ADDENDUM NO. 1

EXECUTIVE ORDER NO. 78954
SPEC. NO. 07-193

SUBJECT: Waterford Estates 98th Street
Water Main Extension
Lincoln, NE

WATER MAIN PLAN

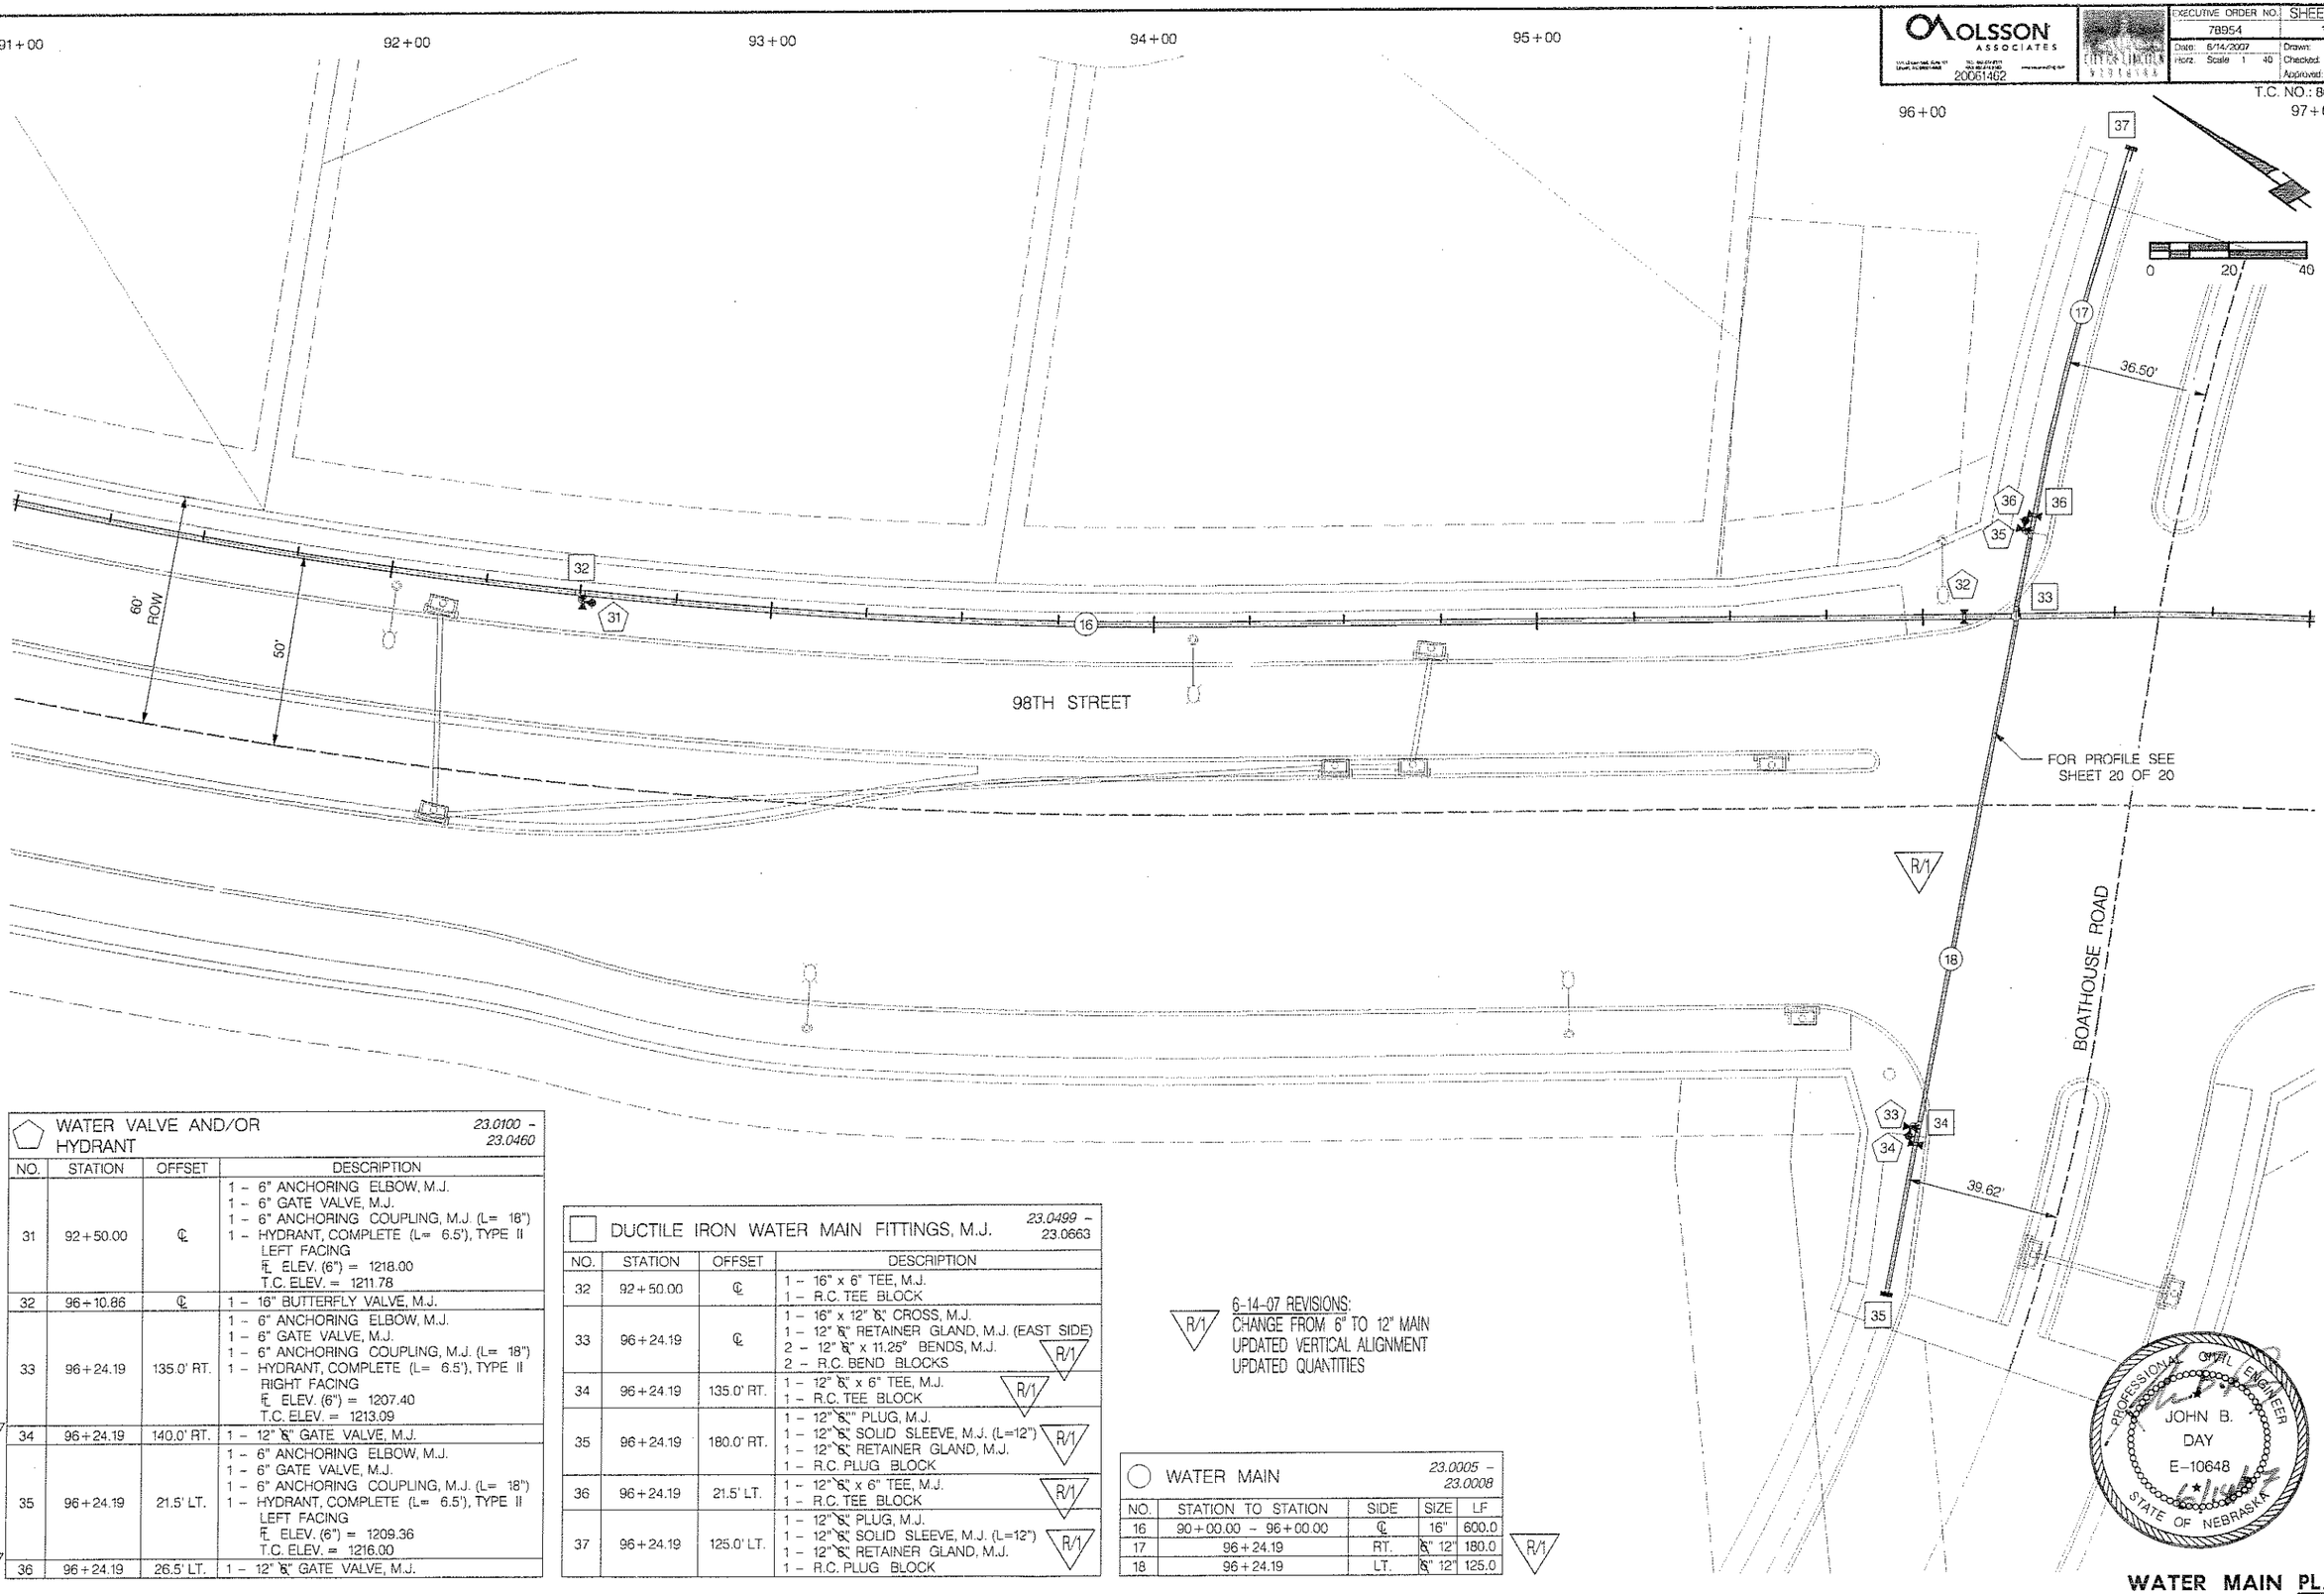
Delete sheets 2, 11 & 20 in their entirety and replace with revised sheets 2, 11 and 20. Sheets have been revised to change the size of water main on Boathouse Drive from 6" to 12". See sheets for descriptions of changed items.

R/1 6-14-07 REVISIONS:
CHANGE FROM 6" TO 12" MAIN
UPDATED VERTICAL ALIGNMENT
UPDATED QUANTITIES

NO.	STATION	OFFSET	DESCRIPTION
31	92+50.00	℄	1 – 6" ANCHORING ELBOW, M.J. 1 – 6" GATE VALVE, M.J. 1 – 6" ANCHORING COUPLING, M.J. (L= 16") 1 – HYDRANT, COMPLETE (L= 6.5'), TYPE II LEFT FACING ℄ ELEV. (6") = 1218.00 T.C. ELEV. = 1211.78
32	96+10.86	℄	1 – 16" BUTTERFLY VALVE, M.J.
33	96+24.19	135.0' RT.	1 – 6" ANCHORING ELBOW, M.J. 1 – 6" GATE VALVE, M.J. 1 – 6" ANCHORING COUPLING, M.J. (L= 18") 1 – HYDRANT, COMPLETE (L= 6.5'), TYPE II RIGHT FACING ℄ ELEV. (6") = 1207.40 T.C. ELEV. = 1213.09
R/1 34	96+24.19	140.0' RT.	1 – 12" ⅋ GATE VALVE, M.J.
35	96+24.19	21.5' LT.	1 – 6" ANCHORING ELBOW, M.J. 1 – 6" GATE VALVE, M.J. 1 – 6" ANCHORING COUPLING, M.J. (L= 18") 1 – HYDRANT, COMPLETE (L= 6.5'), TYPE II LEFT FACING ℄ ELEV. (6") = 1209.36 T.C. ELEV. = 1216.00
R/1 36	96+24.19	26.5' LT.	1 – 12" ⅋ GATE VALVE, M.J.

NO.	STATION	OFFSET	DESCRIPTION
32	92+50.00	℄	1 – 16" x 6" TEE, M.J. 1 – R.C. TEE BLOCK
33	96+24.19	℄	1 – 16" x 12" ⅋ CROSS, M.J. 1 – 12" ⅋ RETAINER GLAND, M.J. (EAST SIDE) 2 – 12" ⅋ x 11.25° BENDS, M.J. R/1 2 – R.C. BEND BLOCKS
34	96+24.19	135.0' RT.	1 – 12" ⅋ x 6" TEE, M.J. R/1 1 – R.C. TEE BLOCK
35	96+24.19	180.0' RT.	1 – 12" ⅋ PLUG, M.J. 1 – 12" ⅋ SOLID SLEEVE, M.J. (L=12") R/1 1 – 12" ⅋ RETAINER GLAND, M.J. 1 – R.C. PLUG BLOCK
36	96+24.19	21.5' LT.	1 – 12" ⅋ x 6" TEE, M.J. R/1 1 – R.C. TEE BLOCK
37	96+24.19	125.0' LT.	1 – 12" ⅋ PLUG, M.J. 1 – 12" ⅋ SOLID SLEEVE, M.J. (L=12") R/1 1 – 12" ⅋ RETAINER GLAND, M.J. 1 – R.C. PLUG BLOCK

NO.	STATION TO STATION	SIDE	SIZE	LF
16	90+00.00 – 96+00.00	℄	16"	600.0
17	96+24.19	RT.	⅋ 12"	180.0
R/1 18	96+24.19	LT.	⅋ 12"	125.0

WATER MAIN PROFILE

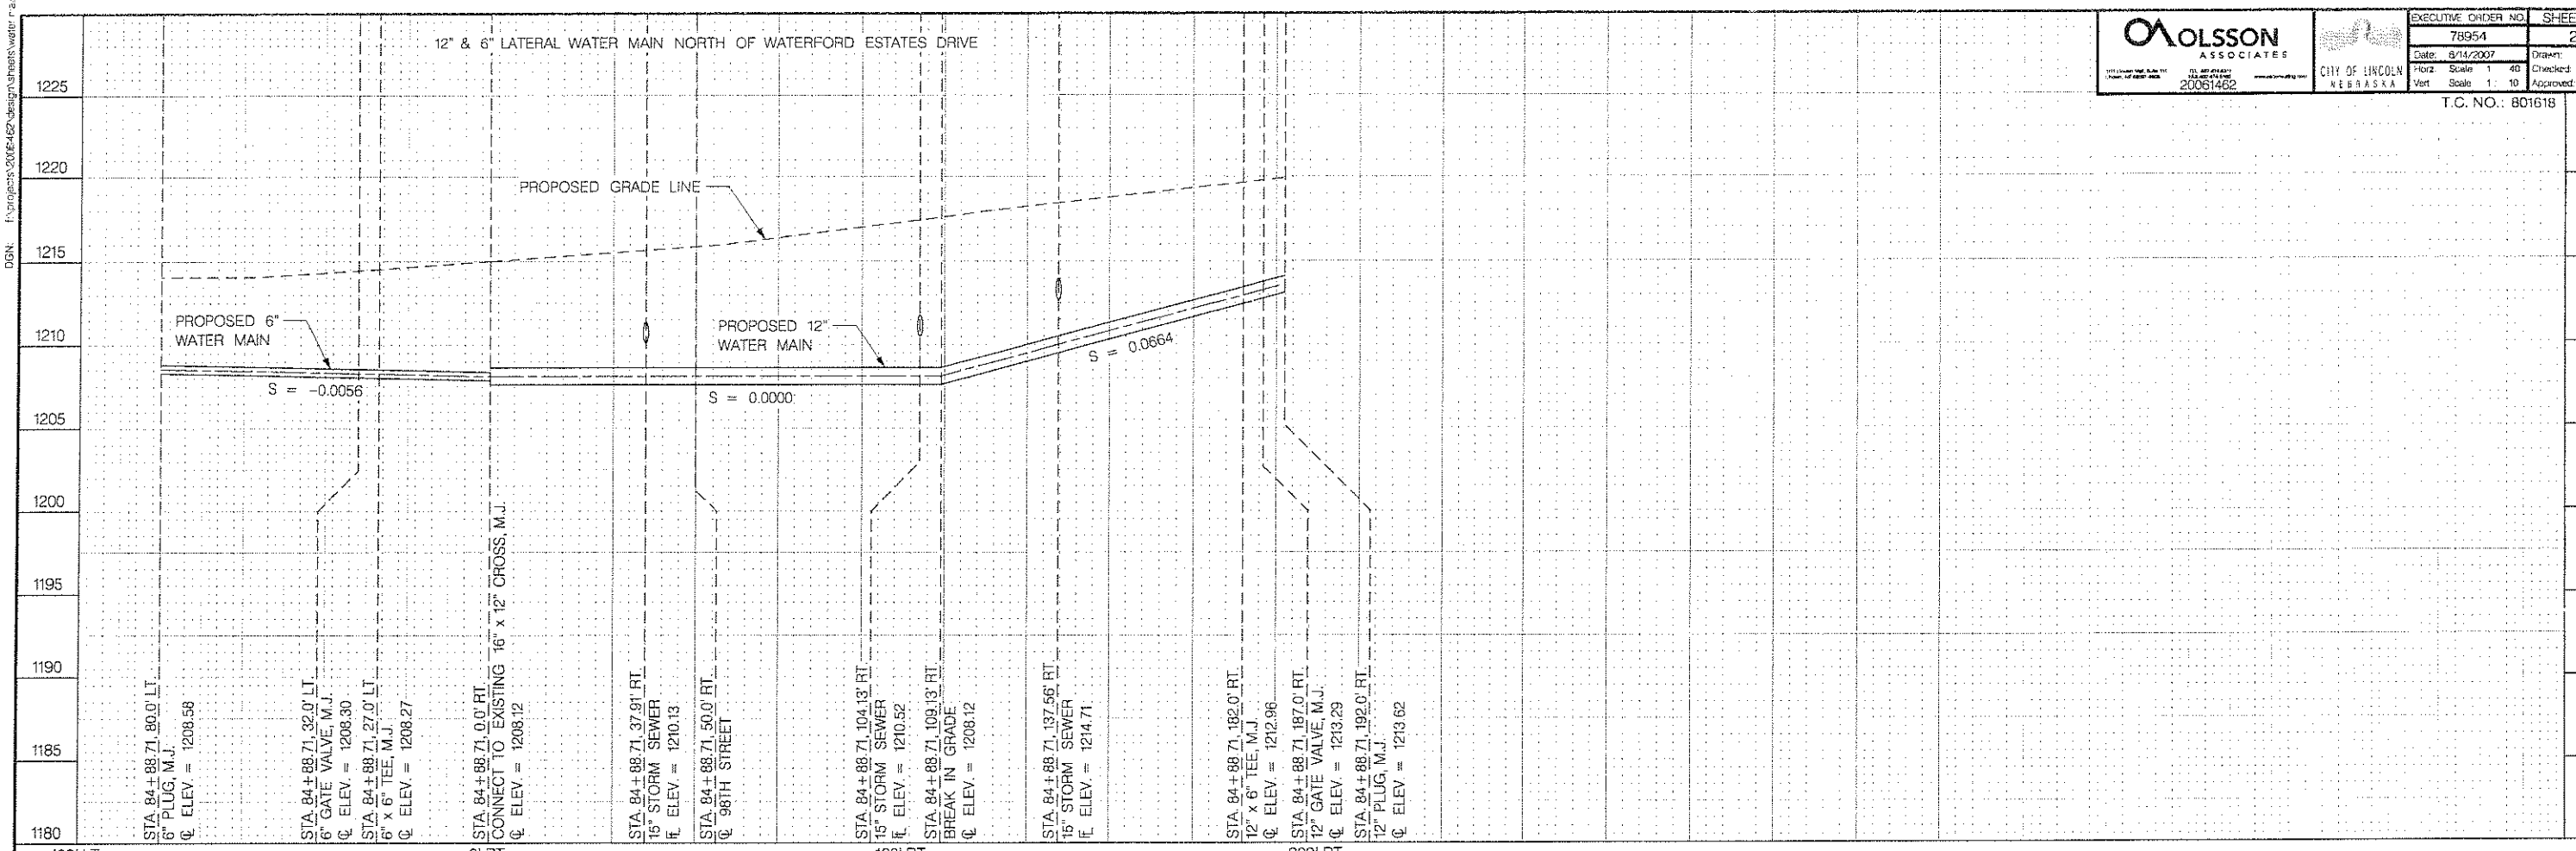
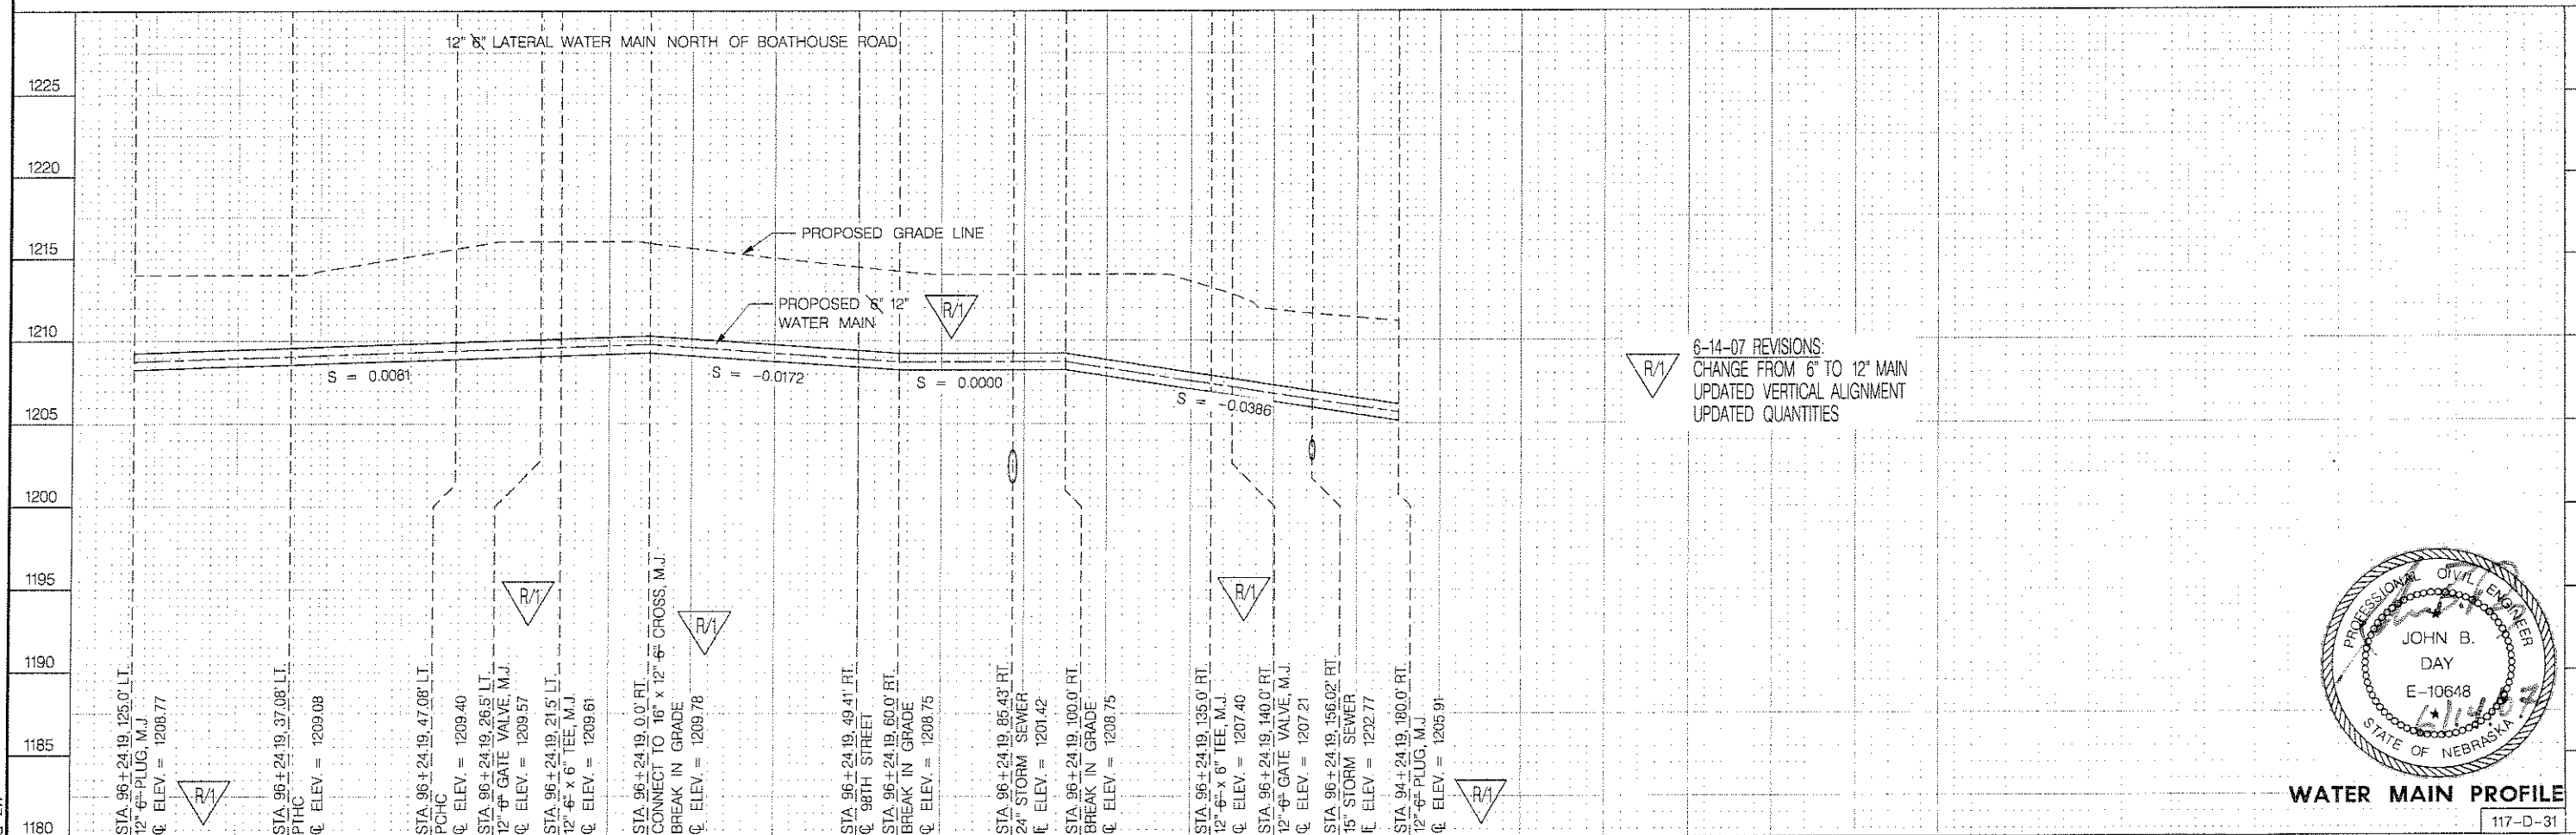
R/1 6-14-07 REVISIONS:
CHANGE FROM 6" TO 12" MAIN
UPDATED VERTICAL ALIGNMENT
UPDATED QUANTITIES

12" & 6" LATERAL WATER MAIN NORTH OF WATERFORD ESTATES DRIVE

12" & 6" LATERAL WATER MAIN NORTH OF BOATHOUSE ROAD
